PRODUCT CHANGE NOTIFICATION SLIDE POTENTIOMETERS

Select Bourns® Model PSM Series Motorized Slide Potentiometer Additional Source of Supply for Motor & Change to Metal Plate, Plate Form and VR Thickness

SC2206

Original Product		Changes with Alternate Supplier	
Plate Form and VR Thickness	() () () () () () () () () ()	13.2 6.3 9.12 9.12 7.HOLES		(13.05) Storest N

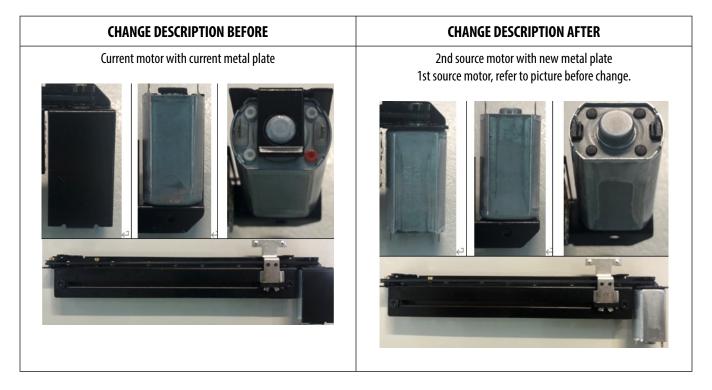
The dimensions of the motor from the additional supplier are slightly longer than those of the original supplier. As such, Bourns will change the metal plate in order to fit motors from both production facilities. The new metal plate will be standard in all Model PSM products regardless of the motor supplier. As provided in the drawings below, the plate form and VR thickness of the products with the original and alternative motor will differ.

Due to the external dimension change caused by the new metal plate on all affected part numbers and the longer motor on products utilizing motors from the additional supplier, the fit of the affected part numbers will change. Due to the plate form, the form of the affected part numbers will change. The function, quality and reliability of the Model PSM Series Motorized Slide Potentiometer remains the same. Traceability is maintained through identification of the motor supplier on the product label.
